**SERVICING DESIGN BRIEF
AND
STORMWATER MANAGEMENT
REPORT**

1420 EARL ARMSTRONG ROAD

TOWN SQUARE CENTRE

**SITE PLAN APPLICATION
FILE No. DO7-12-14-0067**

THERMAL PIPE INSULATION DETAILS

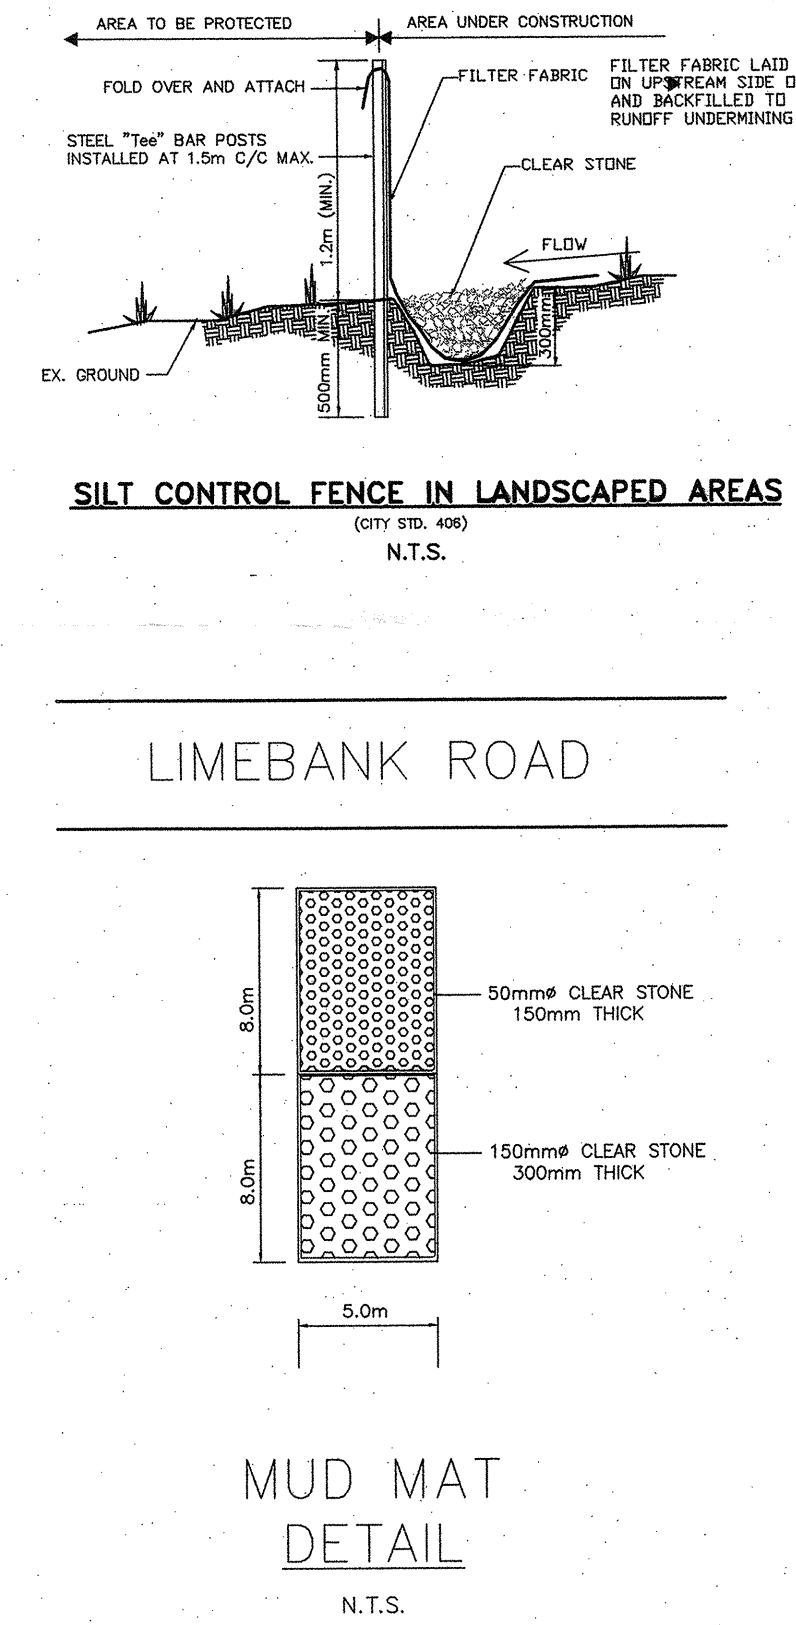
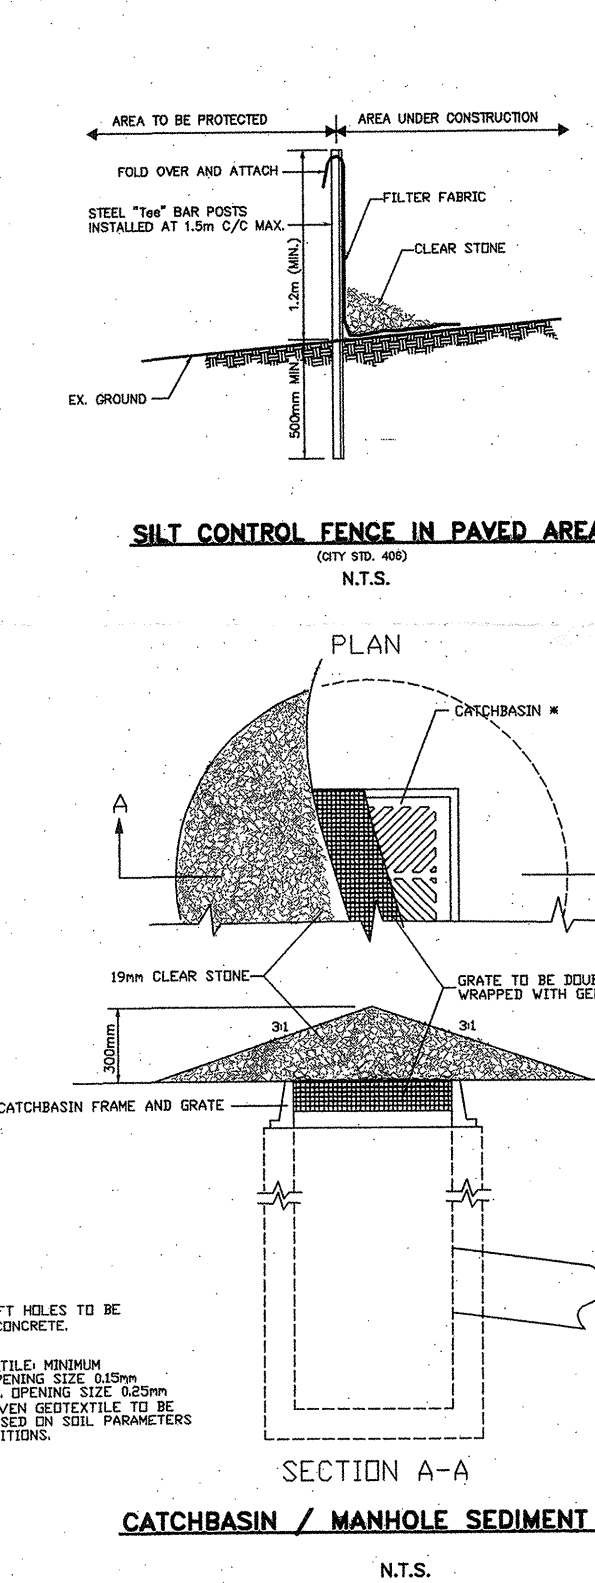
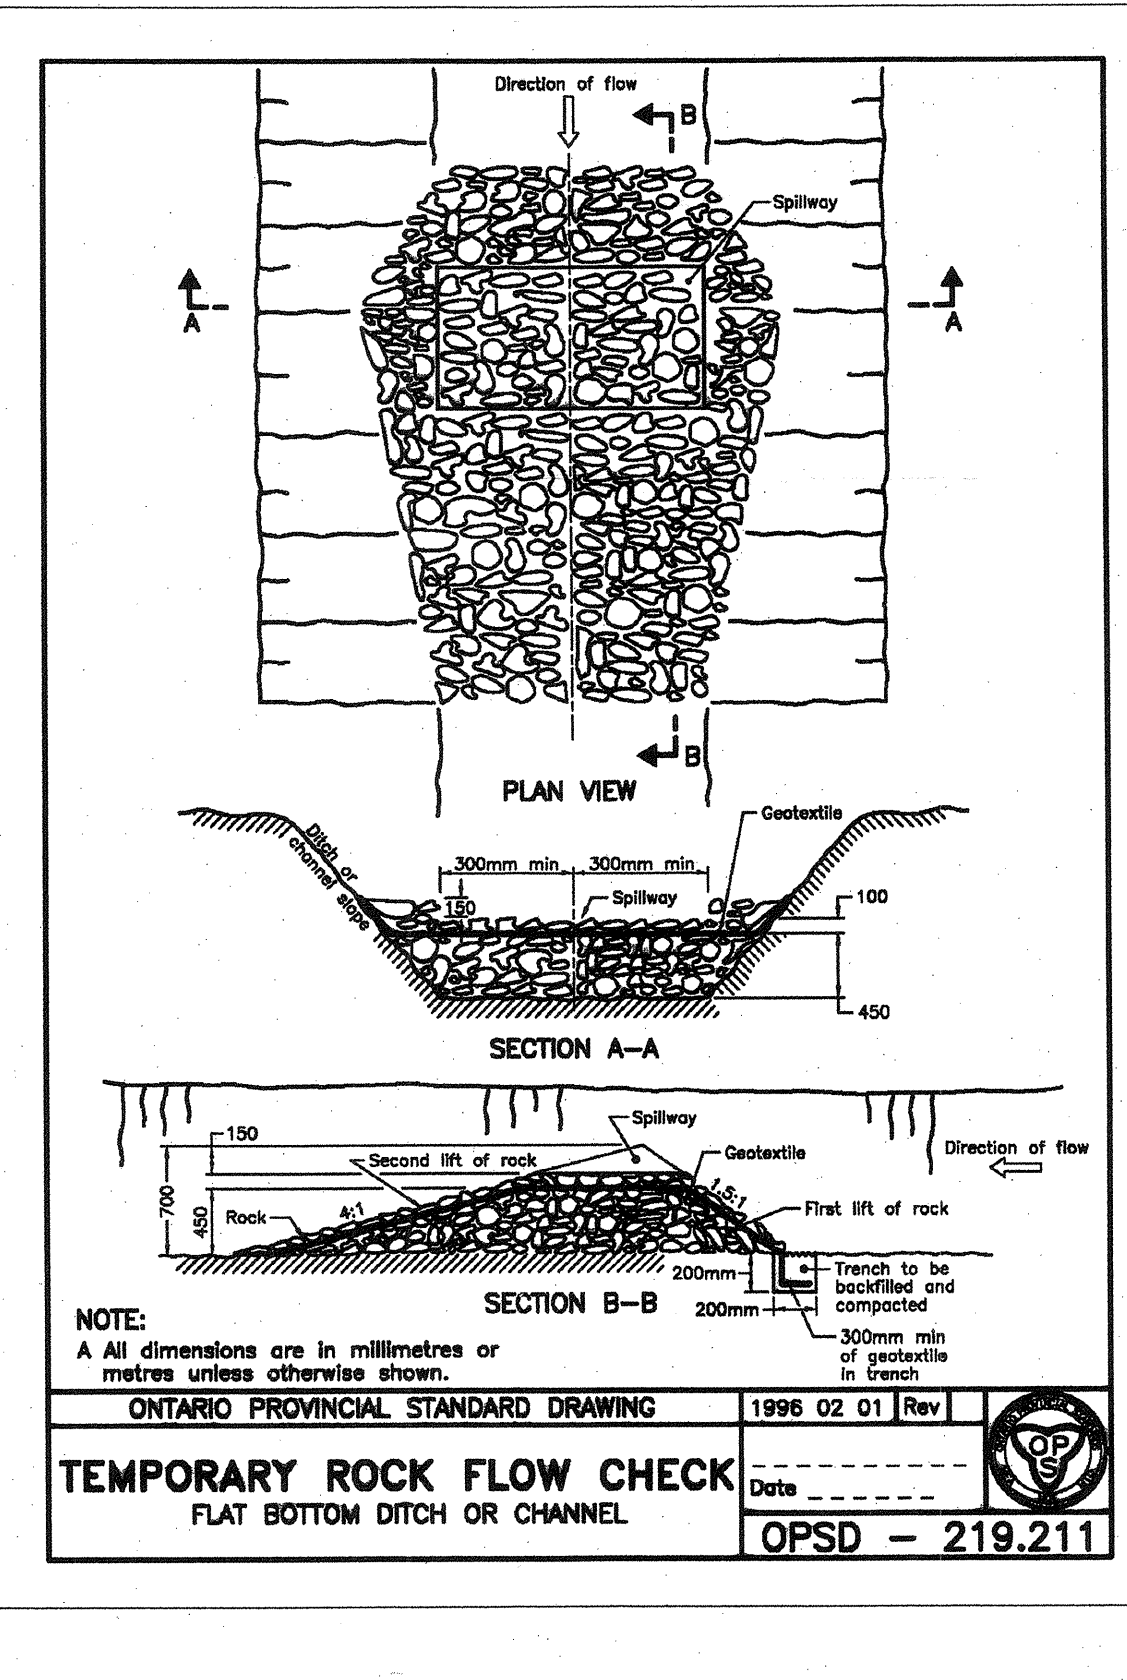
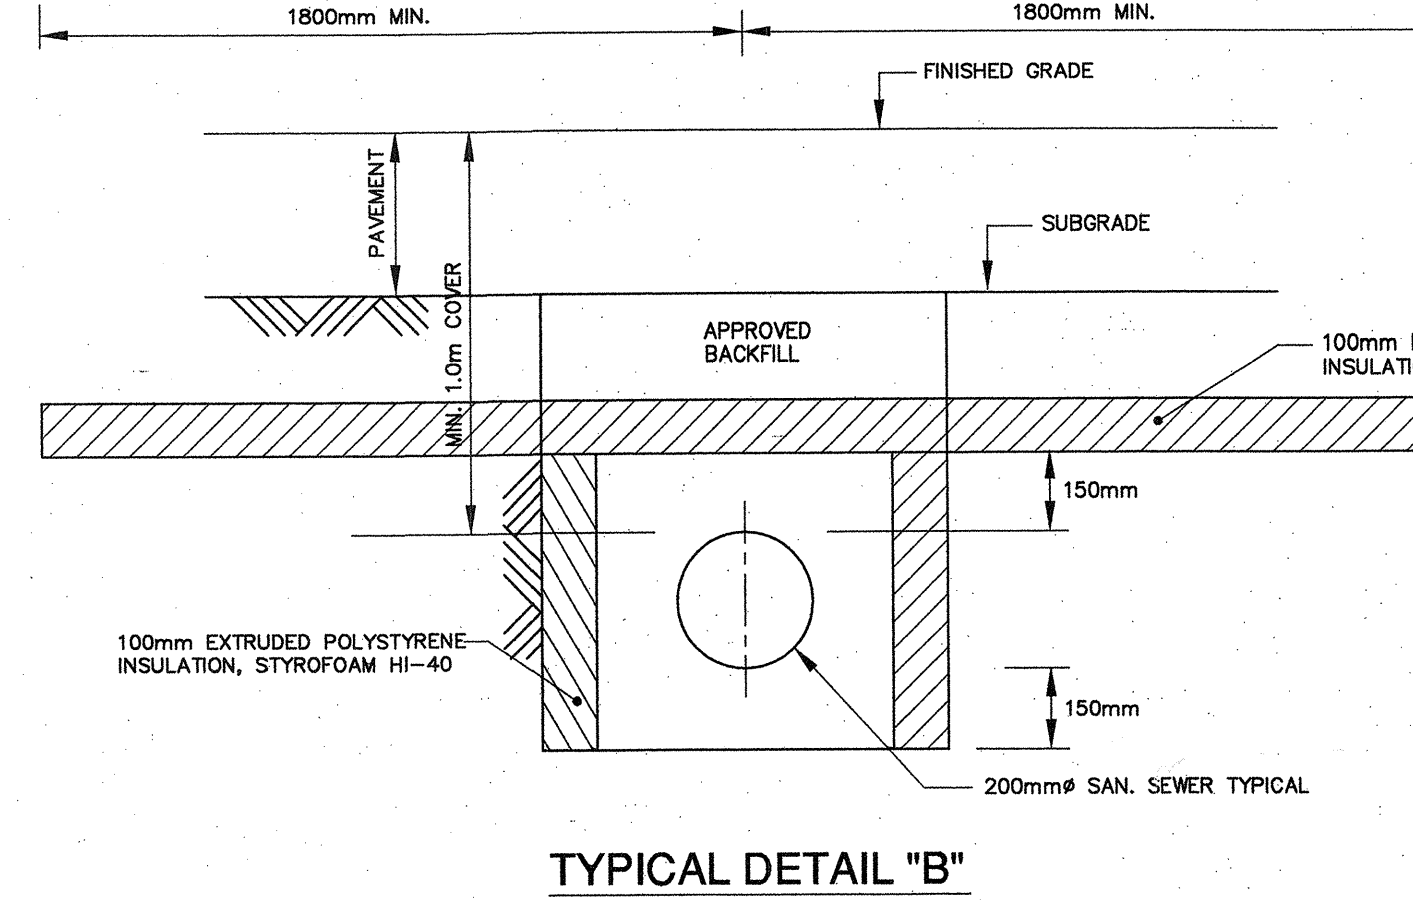
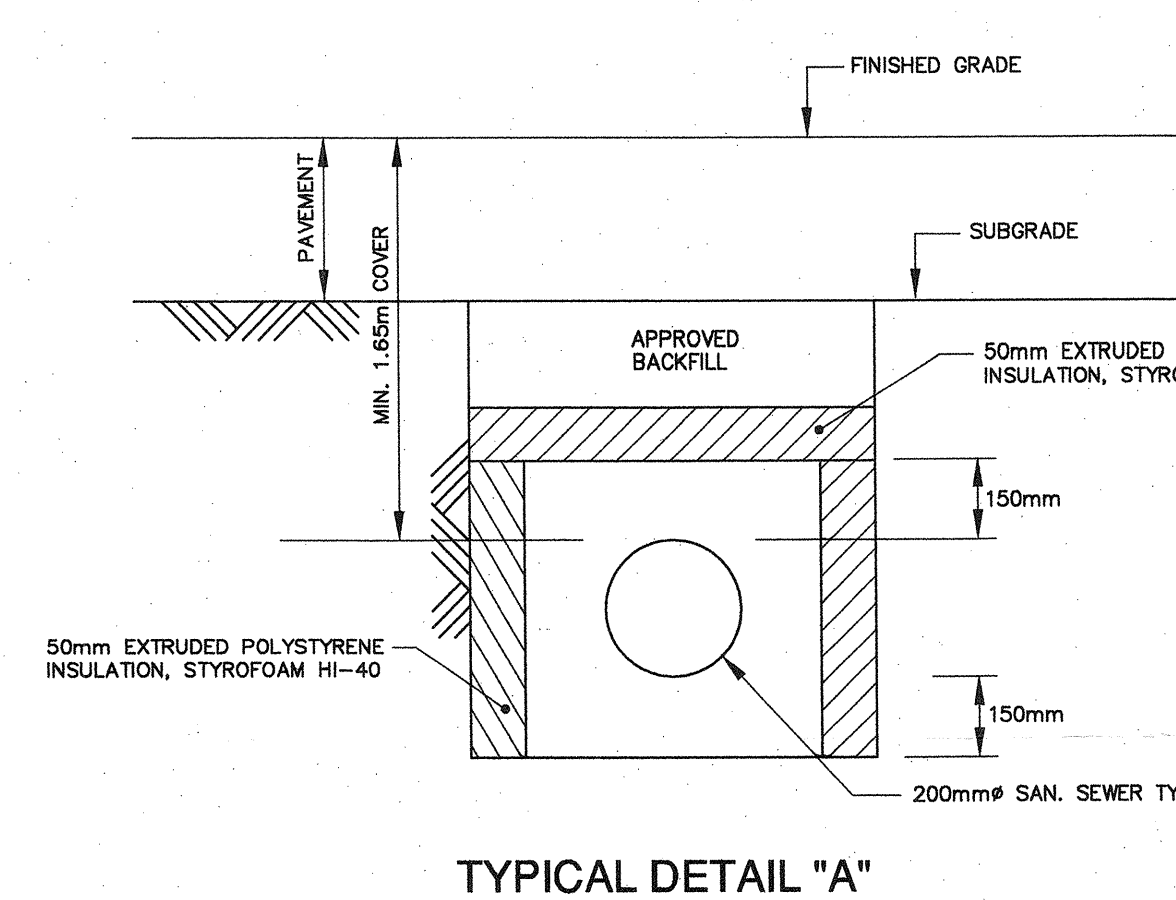
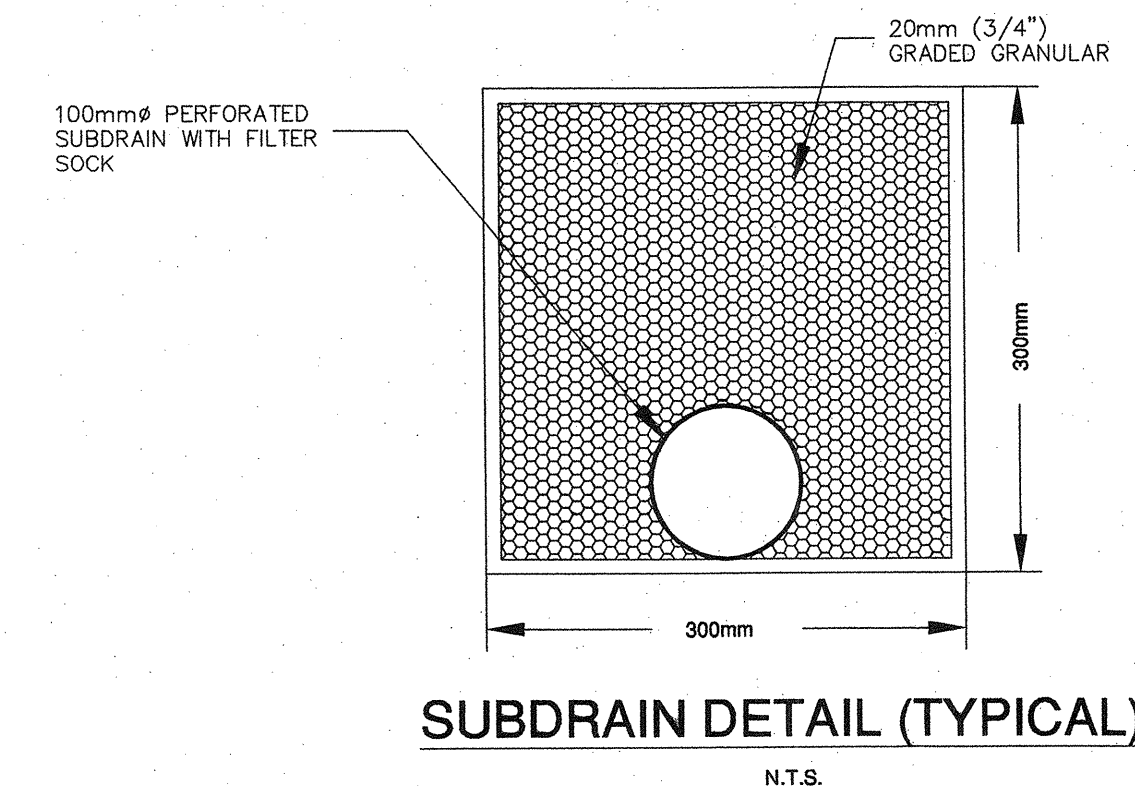
82. General Note #21 please add; “Refer to Servicing drawing 2 of 8 for the number and model# of Zurn control devices required per building.”

83. Add new General Note #24; “ All service trenches to have clay dykes at 60m min. interval per City of Ottawa Drawing #S8

84. Surface Works Note #2 please add; “all site entrances shall conform to City of Ottawa Standard drawing # SC 7.1

85. Watermain and Appurtences please add; shall be PVC CL-150 DR18 conforming to

86. Provide cross-section of sanitary sewer insulation detail c/w insulation thickness (if req'd)

Response: *Note has been revised*

Response: *Special note no. 1 has been added to drawings 2 of 8 and 5 of 8*

Response: *Note has been revised*

Response: *Note has been revised*

Response: *Cross sections have been added to drawing 5 of 8*
